GENTHERM PATIO PERGOLA AND COVERED PATHWAY JSP24-19

Approval of the request of Brian Hughes of Northern Equities Group on behalf of Gentherm for a Section 9 Façade waiver. The subject parcel is 5.94 acres and is located at 28875 Cabot Drive in the Haggerty Corridor Corporate Park in the OST, Office Service Technology district. The request is to construct a wooden pergola and covered pathway on the patio at the rear of the building.

FAÇADE REVIEW

Re: **FACADE ORDINANCE**
Gentherm Patio, JSP24-19,
 Façade Region: 1, Zoning District: OST

PERGOLA ELEVATION
SCALE: 1/4"=1'-0" A-510 **3**

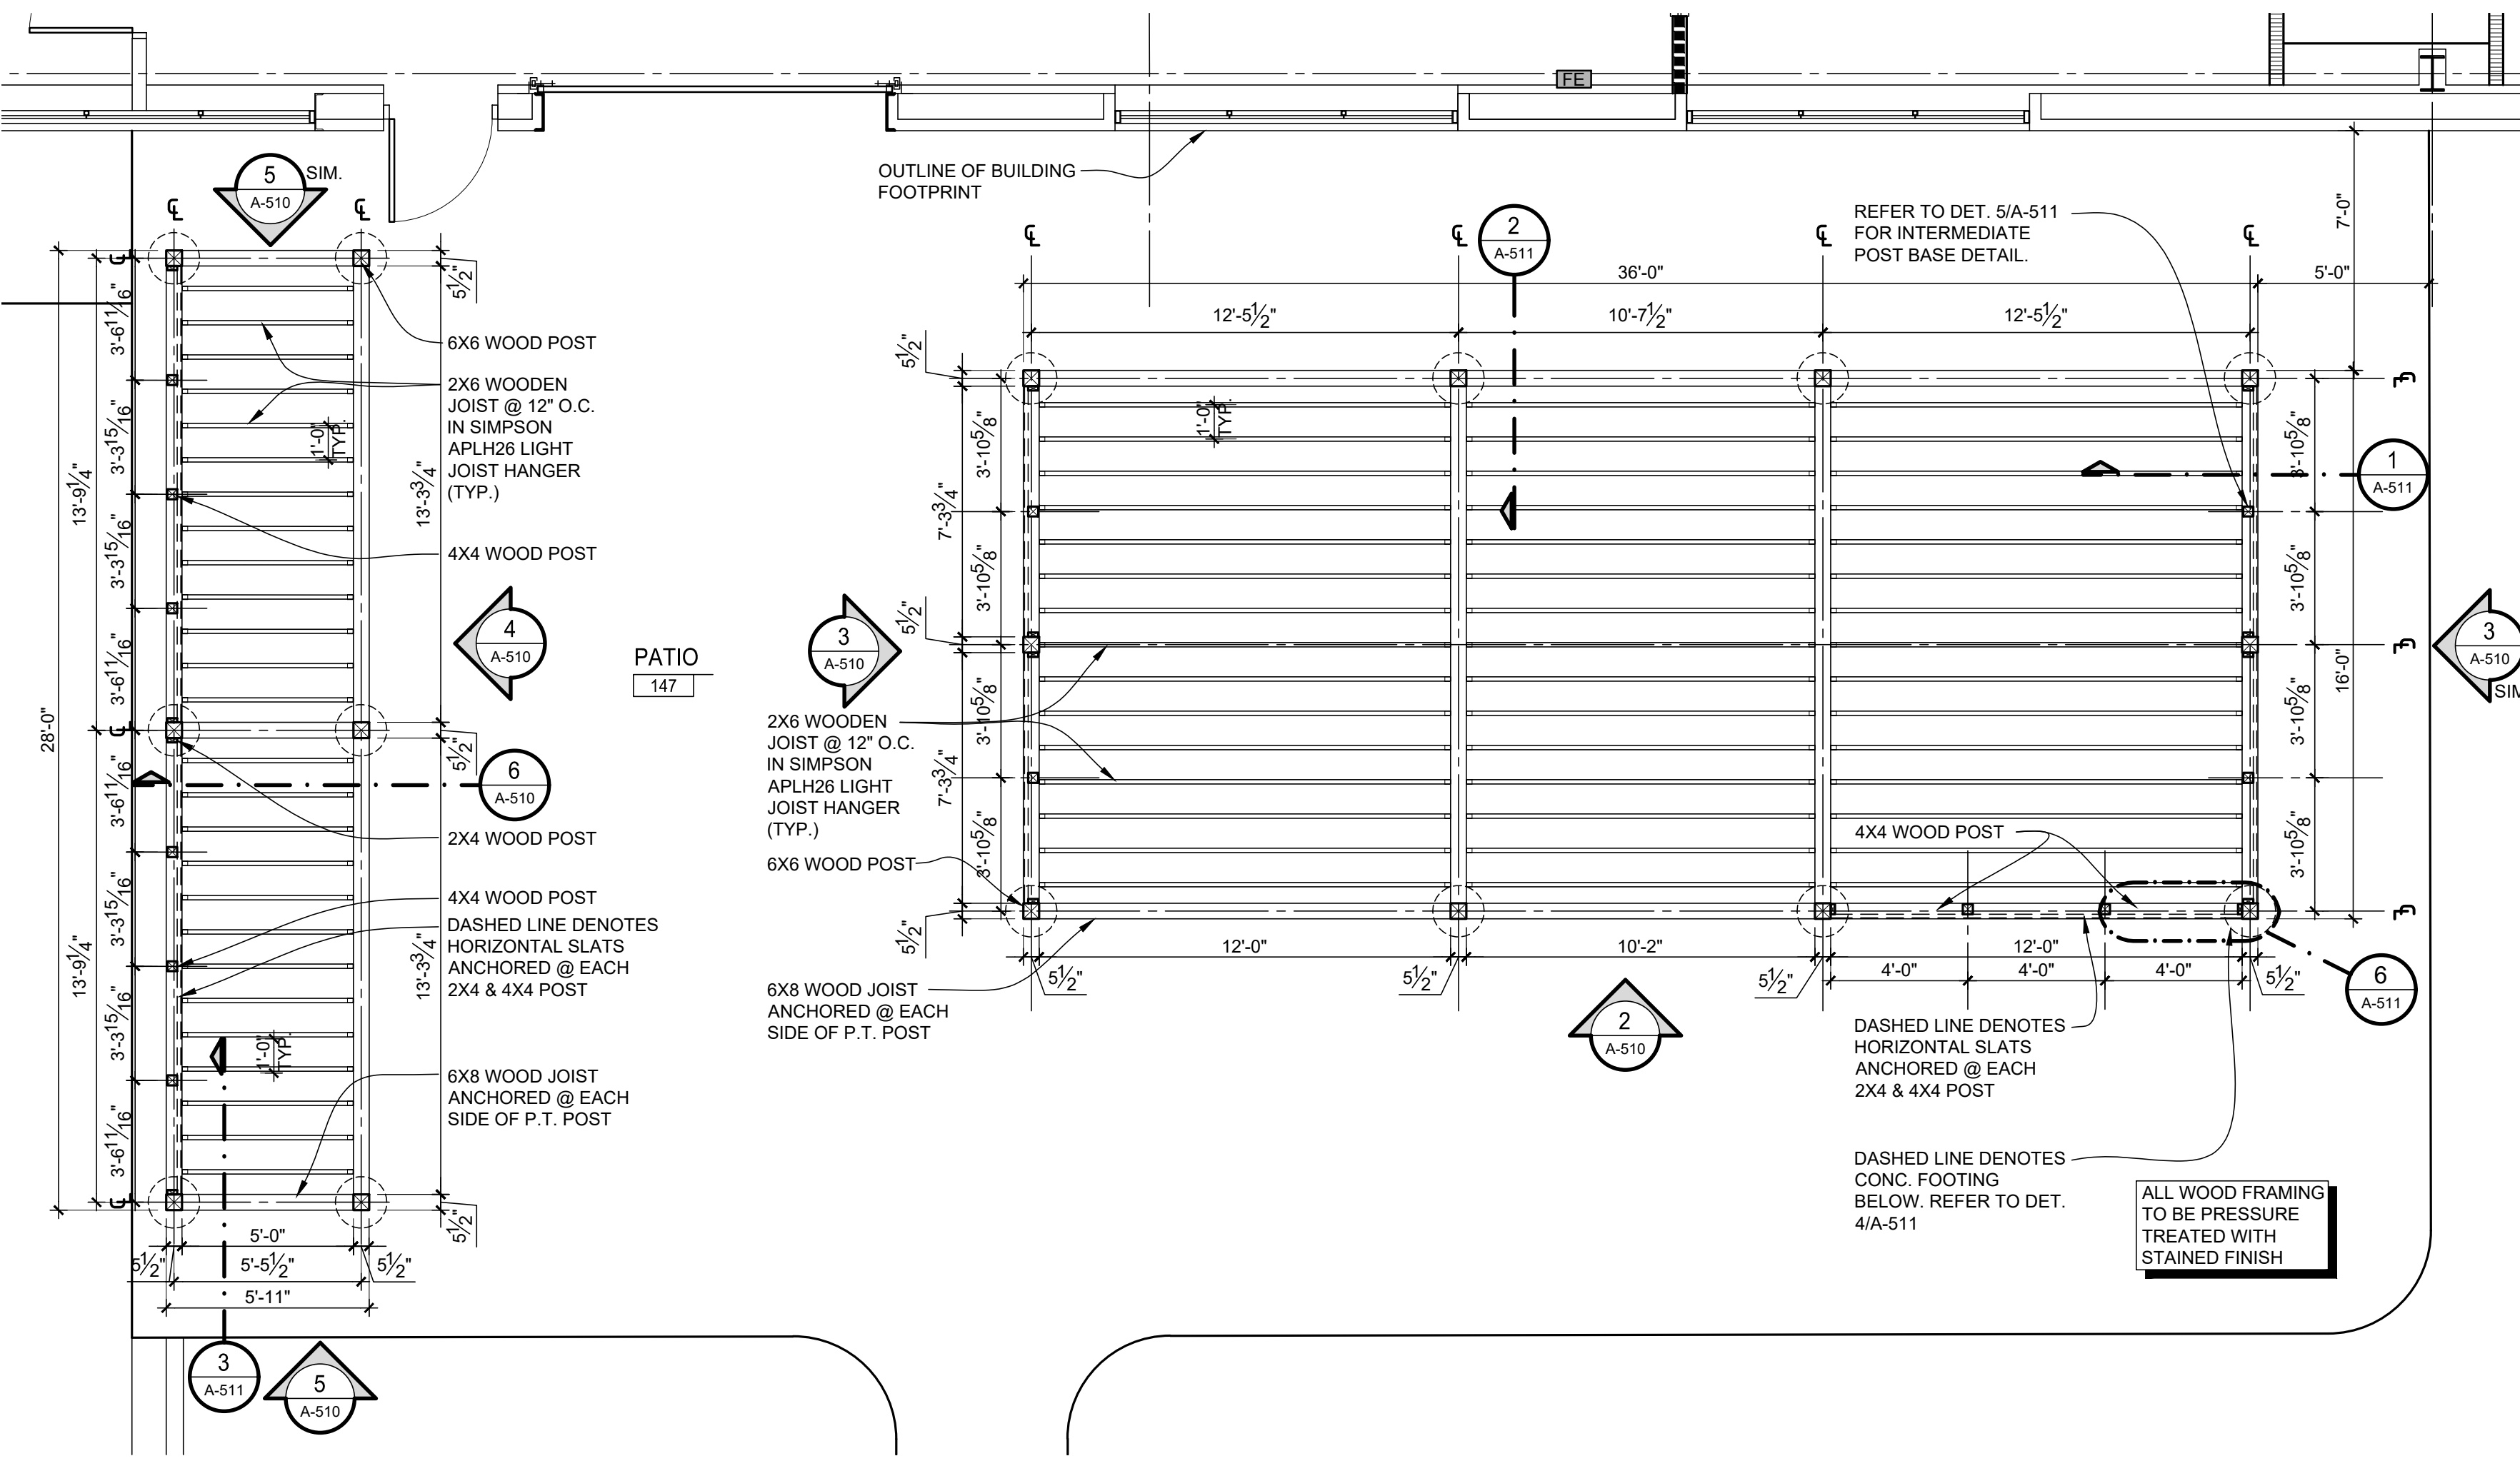
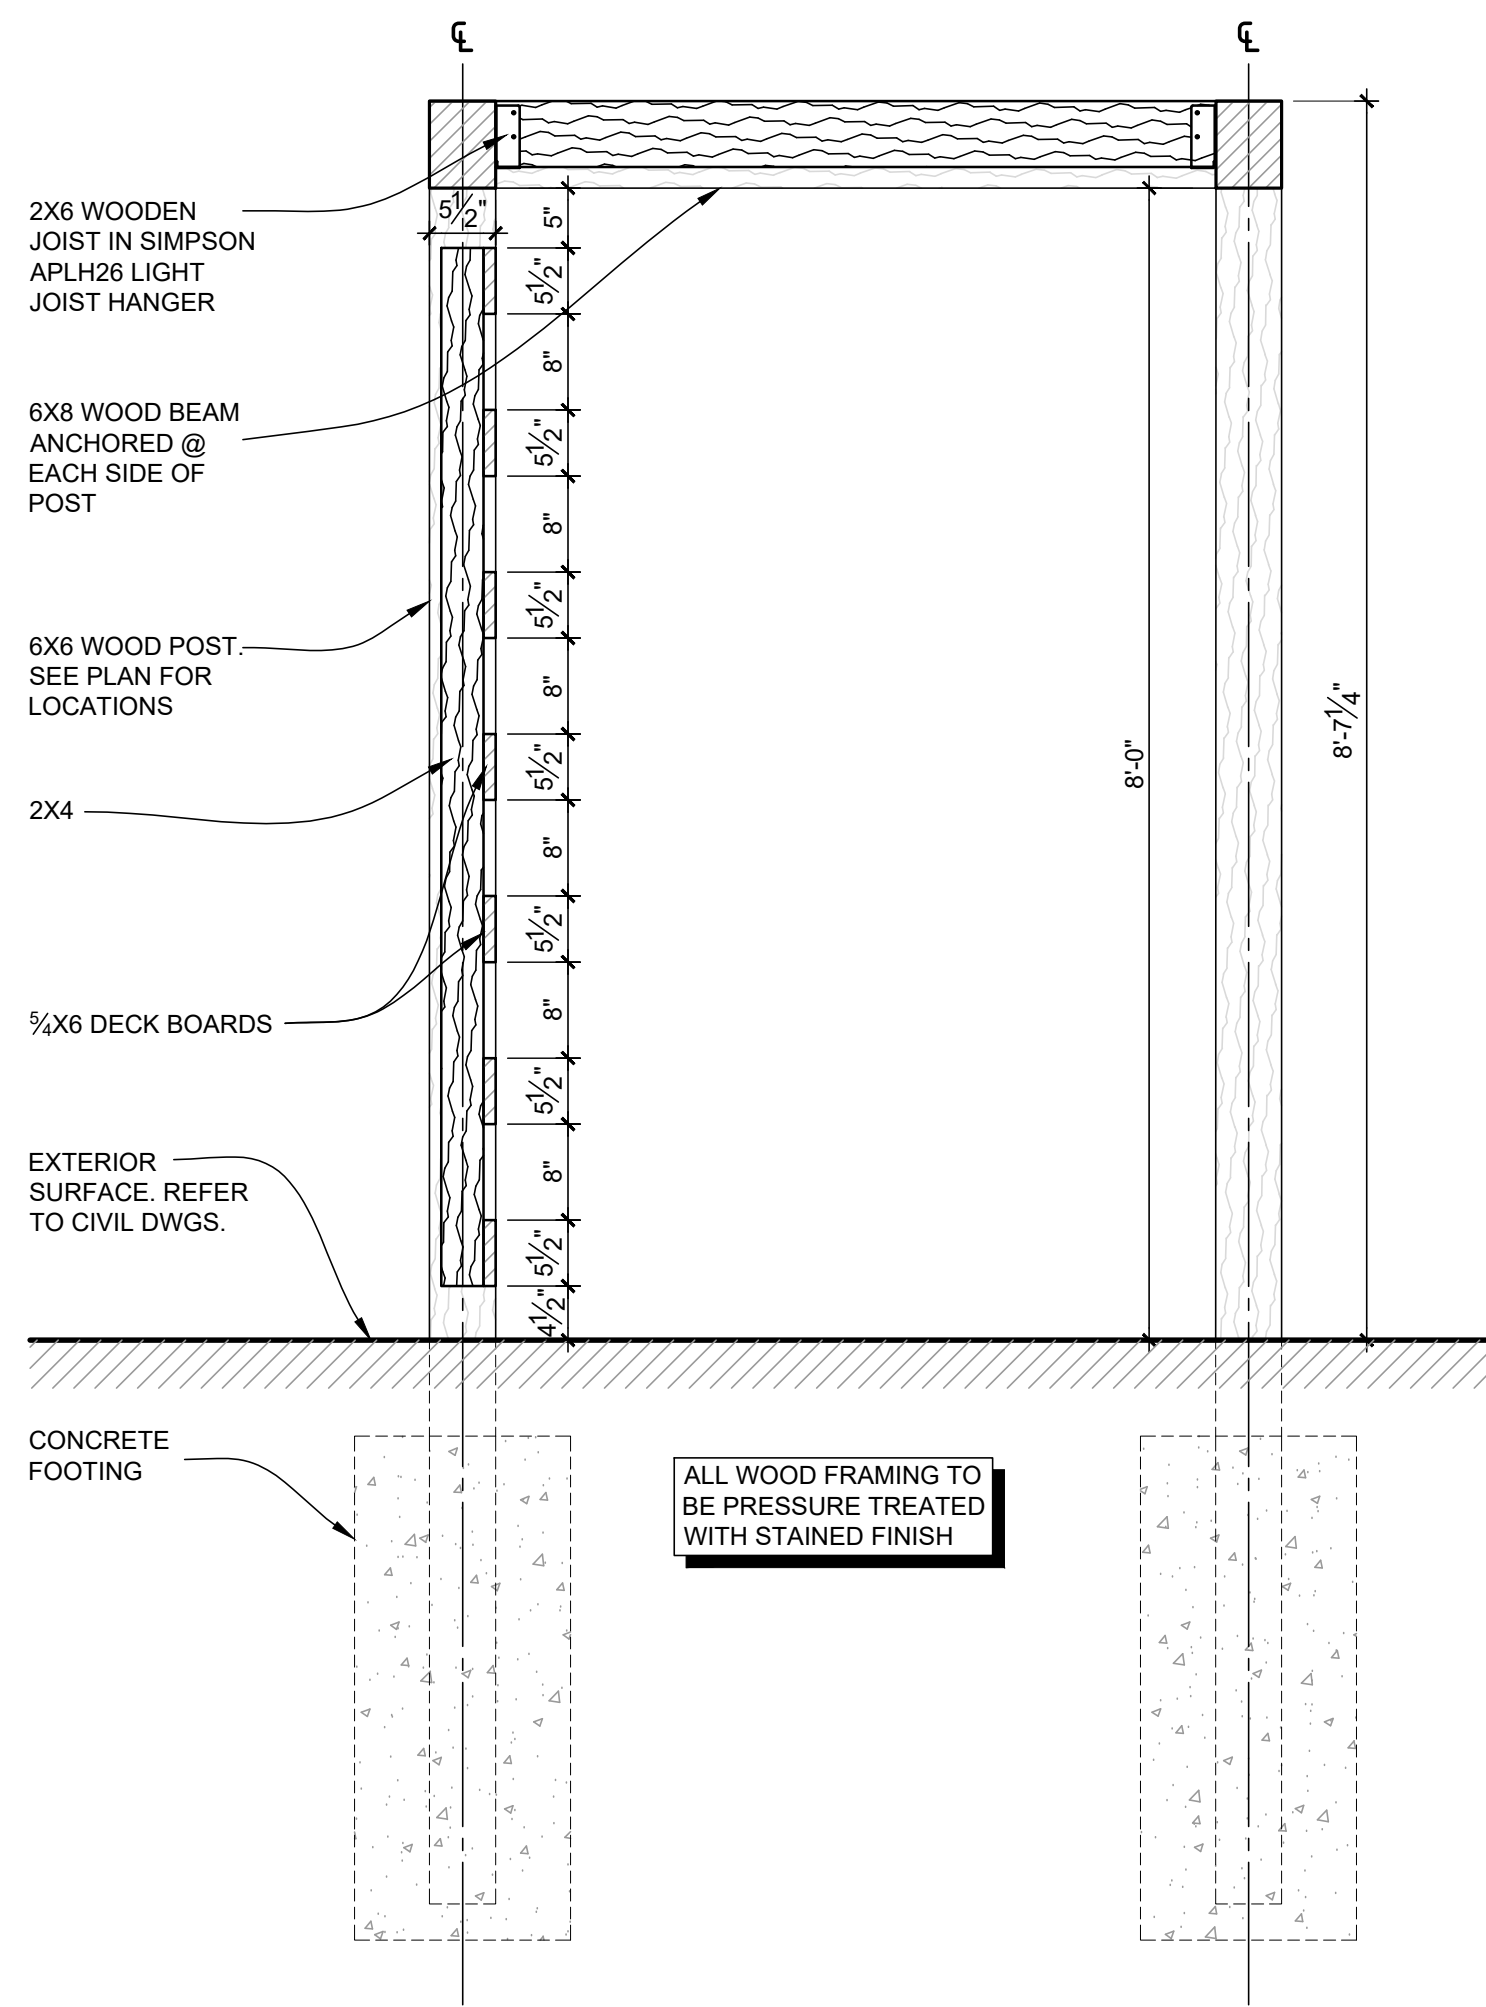
The following Façade Review is based on the drawings prepared by F.A. Studio Architects, dated 11/7/24. The percentages of materials for each façade are shown on the table below. The maximum and minimum percentages required by the Façade Ordinance are shown in the right-hand column. As shown below, all proposed materials are in non-compliance with the Ordinance.

South (Front)	North	East	West	Ordinance Maximum
Natural Wood w/ Stain Finish	100%	100%	100%	100%	0%

The proposed pergola structures are considered a canopy as described in Section 5.15.12 of the Façade Ordinance. The Ordinance requires that not less than 30% of the façade materials used on canopies be identical to the primary building. In this case the primary building is Brick. The proposed structures are constructed entirely of natural stained wood. Therefore, a Section 9 Waiver would be required for this deviation.

Recommendation - In this case the proposed structures will not be visible for Cabot Drive of the M-5 highway. Therefore, we recommend that the proposed structures are consistent with the intent and purpose of the Façade Ordinance and that a Section 9 Waiver be granted for the underage of brick and overage of stained wood.
